REPORT AMENDED BY STAFF & CPC 3-8-90
REPORT AMENDED BY STAFF 2-14-90
CITY PLANNING COMMISSION
1231 "I" STREET, SUITE 200, SACRAMENTO, CA. 95814

- APPLICATION:**
- A. Negative Declaration
 - B. Amendment to Pocket Community Plan to allow back-up lots adjacent to the Sacramento River Parkway and reduce the 40 foot levee easement to 20 feet
 - C. Rezone of 9.7+ partially developed acres from Agriculture (A) zone to Standard Single Family (R-1) zone
 - D. Tentative Map to divide 9.7+ partially developed acres into 19 23 single family, 8-halfplex lots, and one lot to be dedicated to the City for parkway (amended by staff)

APPLC. NO. P89-158

TENTATIVE SUBDIVISION MAP
CARRIAGE ESTATES

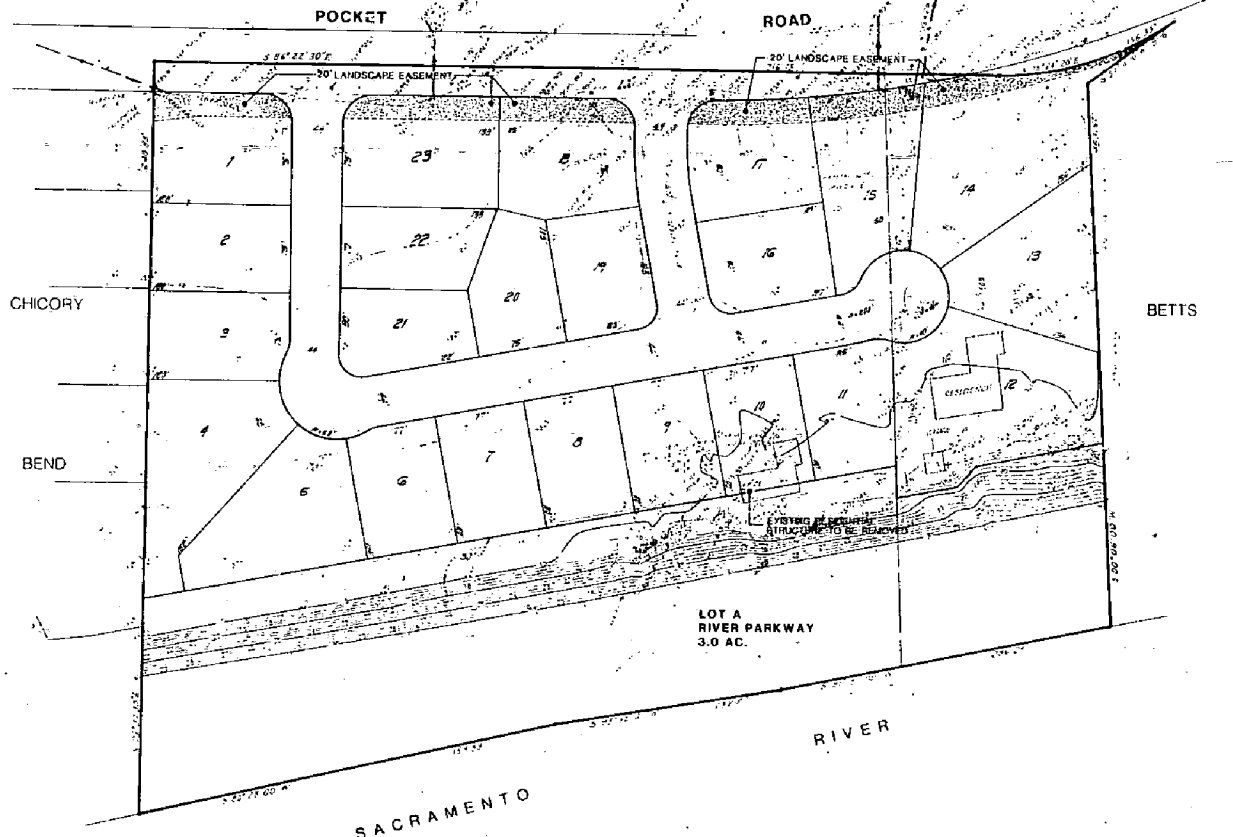
Staff can find no compelling reason to establish a precedent in amending the plan. Staff recommends that the proposed tentative map be denied and that the map be redesigned and resubmitted showing a lotting pattern similar to Exhibit D reflecting elimination of back-on lots and providing a 30 foot levee landscape parkway.

The proposed tentative map shows a total of ~~28~~ 24 lots with ~~19~~ 23 standard single family lots, 8 halfplex lots and one Lot A to be dedicated to the City of Sacramento as part of the Sacramento River Parkway. ~~No plans were submitted for the halfplex units.~~ Lots 6 to 13 are back-on lots to the parkway with a 20 foot landscape and levee maintenance easement shown from the toe of the levee to the rear property line of the lots. Lot 13 is proposed to retain the Silva family residence. The dwelling on Lot 11 is to be

Staff does not support the map design as previously stated based upon comments received from the Parks Department, Exhibit C, and inconsistency with the Pocket Community Plan. The applicant has provided arguments for the proposed map and has provided 5 conditions acceptable to his client if the tentative map is approved (refer to Exhibit E).

Access onto Pocket Road is restricted from each of the proposed halfplex lots due to a 25 foot landscape parkway adjacent to Pocket Road. No driveways to halfplex units are allowed off Pocket Road. A joint driveway from the interior streets shall provide access to both units. Absent detailed elevations and floor plans, staff recommends Planning Director review of halfplex units prior to issuance of building permits.

The applicant has also proposed 10 feet of landscaping adjacent to Pocket Road as a continuation of LPPT Parkway. The original tentative map for Carriage Estates showed a 25 foot wide landscape parkway adjacent to pocket Road. A green belt adjacent to Pocket Road has been installed adjacent to the subject site which ranges in width from 6 feet to 20 feet. This appears to have been installed at the time street improvements were constructed. Portions of the existing turn-out and curb, gutter and sidewalk adjacent to the site will require removal and redesign. Staff would recommend continuation of the 25 foot wide parkway adjacent to Pocket Road as shown in the original tentative map.

With the above considerations in mind, the Planning Division staff and Parks and Recreation Department staff recommend denial of the proposed tentative map and advise the applicant to redesign the map to comply with the policies and goals of the Pocket Community Plan, Sacramento River Parkway Plan, and the treatment to Pocket Road as stated in the LPPT PUD Guidelines.

14. Show a 20 30 foot parkway easement from the toe of the levee. Show toe of levee on final map; *(amended by staff)*
15. Dedicate the southwesterly 5 feet of Lot 14 as a public utility easement for underground electrical and public utility facilities and appurtenances;

23. Eliminate the meandering lot line on parcel 13 and replace with a boundary line more easily described in a legal description;

28. The subdivider shall offer to sell to the City a 20 30 foot wide strip between the toe of the levee and the rear lot lines of the lots backing on the levee, excepting lot 13. This strip shall be inclusive of any easement area in favor of any public entity between the toe of the levee and the rear lot lines (lots 5 through 13, inclusive). ~~This strip subdivider shall be landscaped with~~ *this strip with* native trees on approximately 30 foot centers and irrigated to the satisfaction of the Department of Parks and Community Services; *(amended by staff)*

31. If and when the Silva residence currently located on lot 13 is removed from lot 13, the owner of lot 13 shall sell an additional ten (10) foot strip on the levee side of lot 13 for the same price as the unencumbered portion of the property behind lot 13 was sold to the City. (Added by staff)
32. 31. A decorative masonry wall fence shall be reviewed and approved by the Planning Director for those lots adjacent to Pocket Road. Design and color of the six foot high wall shall be compatible with similar walls along the Pocket Road Parkway. (amended by staff)
- *33. Subdivider shall provide a 20 foot landscaped easement parallel to the City right-of-way. (staff added)
- *34. The map shall be redesigned to provide public access to the Sacramento River. (CPC added)
